Economic Commission for Europe**Administrative Committee for the TIR Convention, 1975****Technical Implementation Body****Third session**

eTIR conceptual, functional and technical specifications:**Version 4.4:****Concrete amendment proposals****Concrete amendment proposals*****Note by the secretariat****I. Introduction and mandate**

Figure I
Current customs management of guarantees class diagram

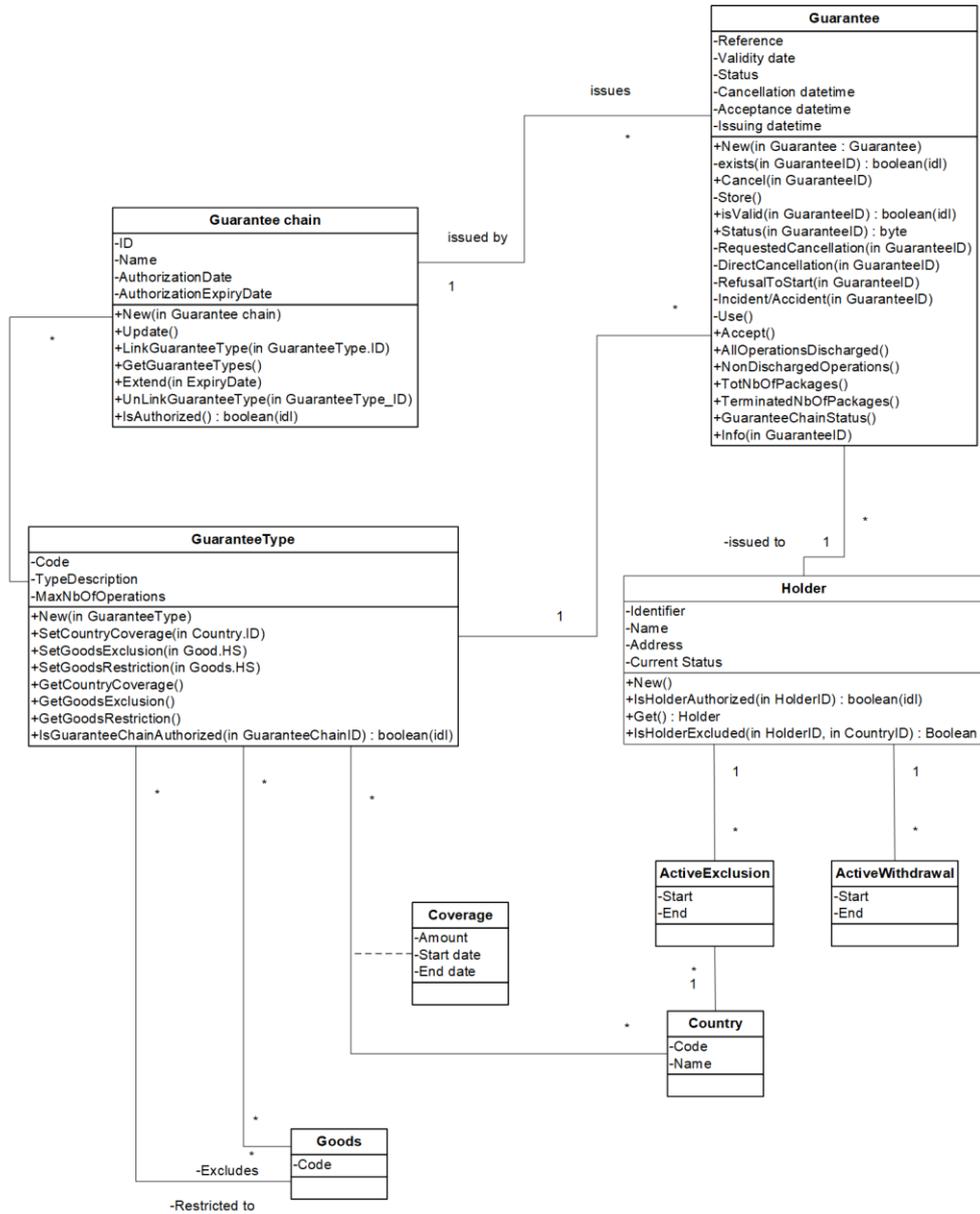
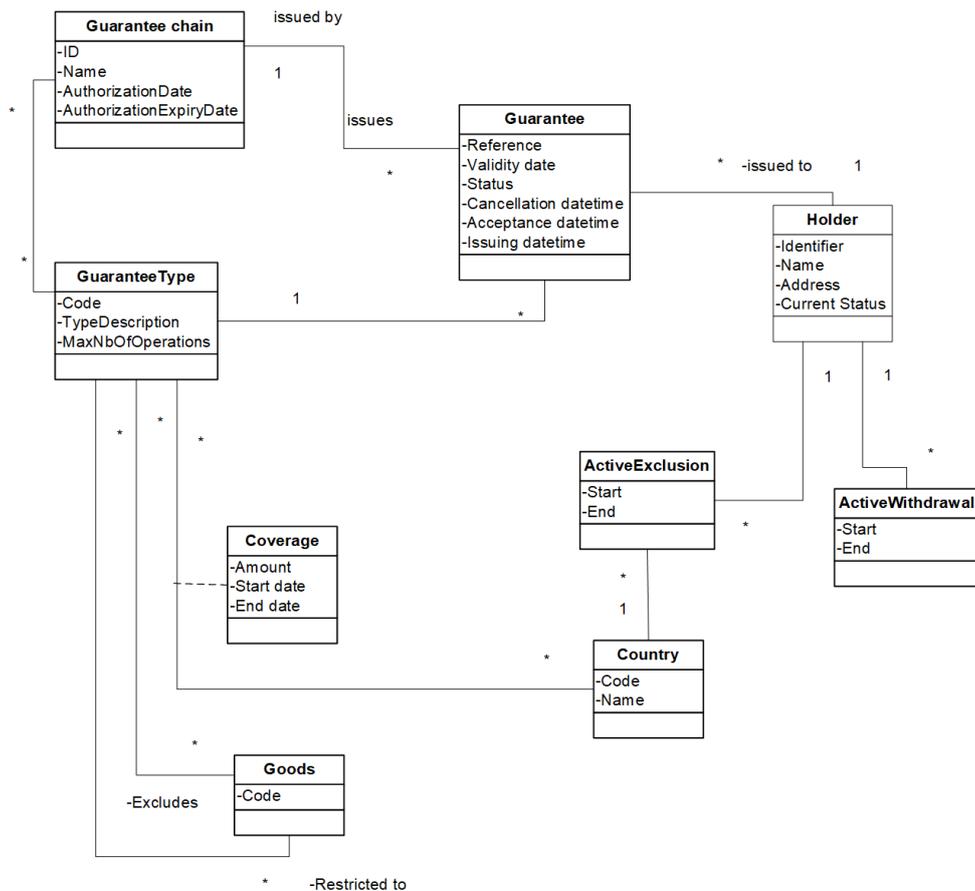
31. UML Class diagrams used in version 4.3 of the eTIR functional specifications contain not only classes, their relationships and their attributes, but also a set of methods that were aimed at facilitating the development of the eTIR international system. As such, these methods have little to no use for the countries that wish to amend their customs system to implement the eTIR procedure. Figures I and II below show the difference between the current and the simplified version of the customs management of guarantees class diagram (Figure 1.19 of the eTIR functional specifications).

Figure II
Simplified customs management of guarantees class diagram

Figure III
 UML activity diagram for the Start TIR operation process

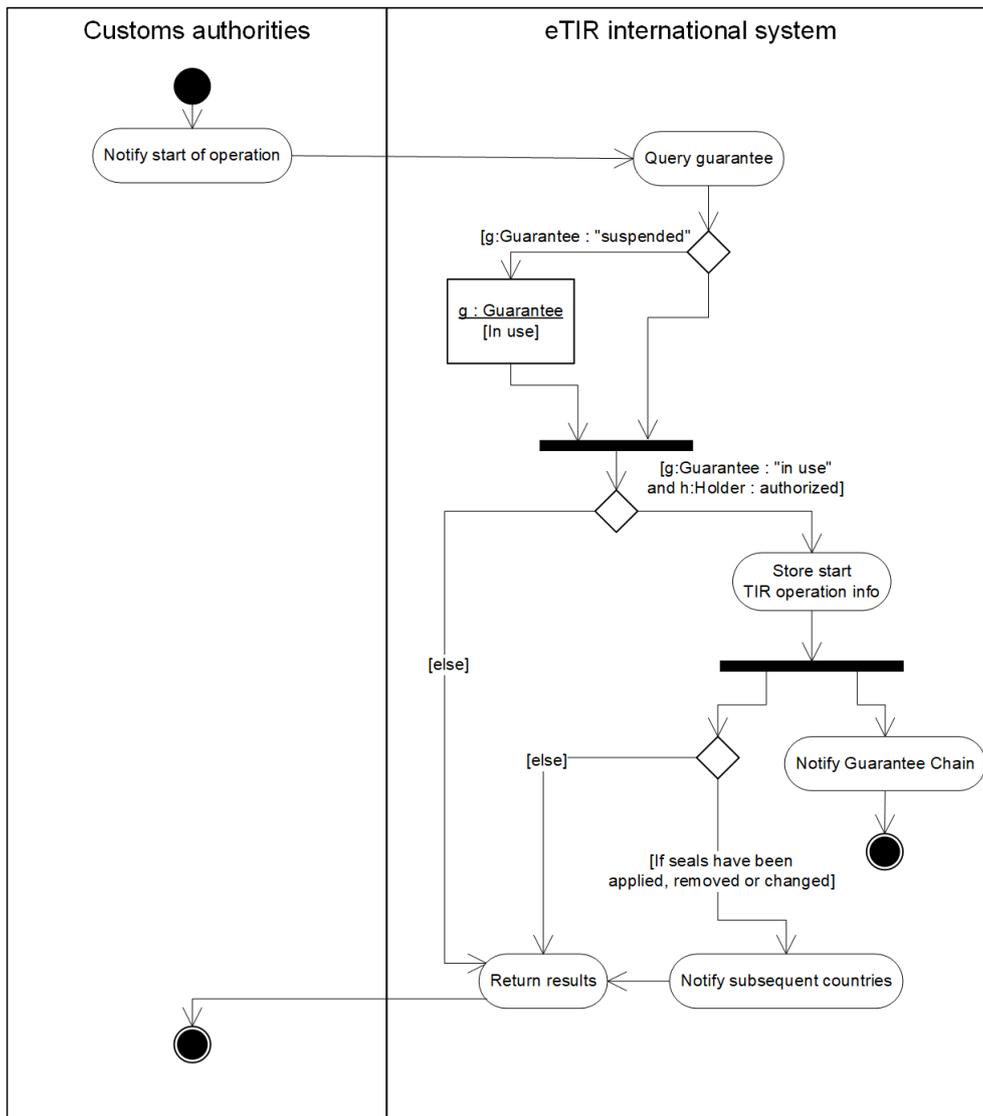
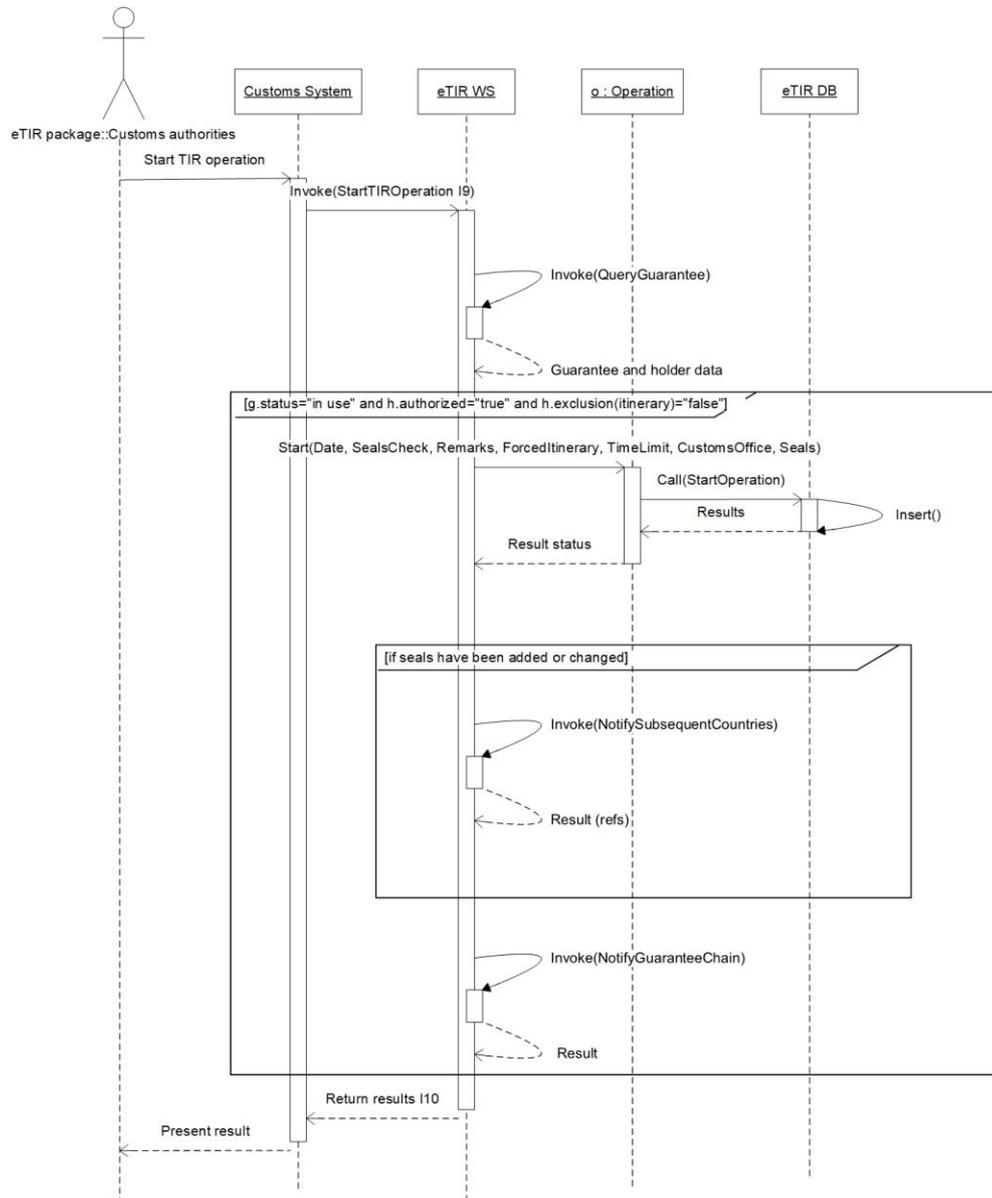
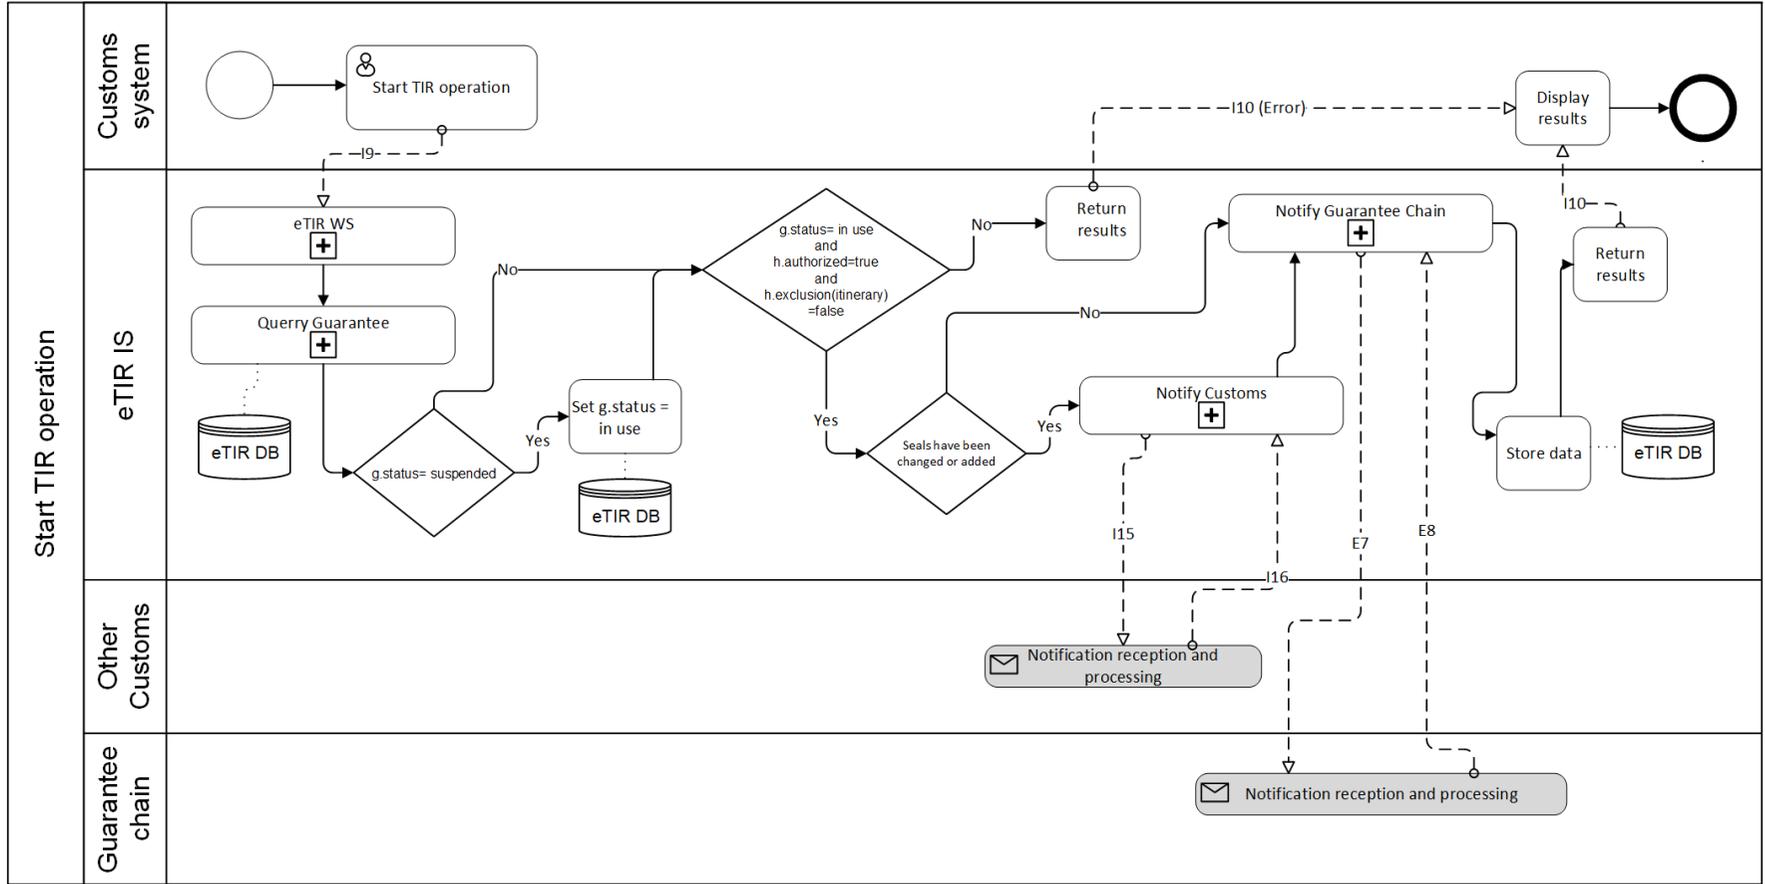
32. In version 4.3 of the eTIR specifications, in line with the Unified Modelling Methodology (UML) chosen originally for the eTIR project, the modelling of processes is done using UML activity and sequence diagrams. In recent years, the business process model and notation (BPMN) has gained in popularity in both the business and Information and Communication Technologies (ICT) communities and is, therefore, better understood by laymen and experts alike. With that in mind, TIB might wish to consider if, in version 4.4 of the eTIR specifications, BPMN should replace the activity and sequence diagrams used in version 4.3. Figures III, IV and V below show the UML activity diagram (Figure 12 of the eTIR concepts), UML sequence diagram (Figure 1.9 of the eTIR functional specifications) and the Business Process Diagram for the Start TIR operation process.

33. TIB might wish to consider the various diagrams and instruct the secretariat where BPMN diagrams should be used. TIB might also wish to consider the need to keep some of the UML diagrams and in which part of the documents composing the eTIR specifications.
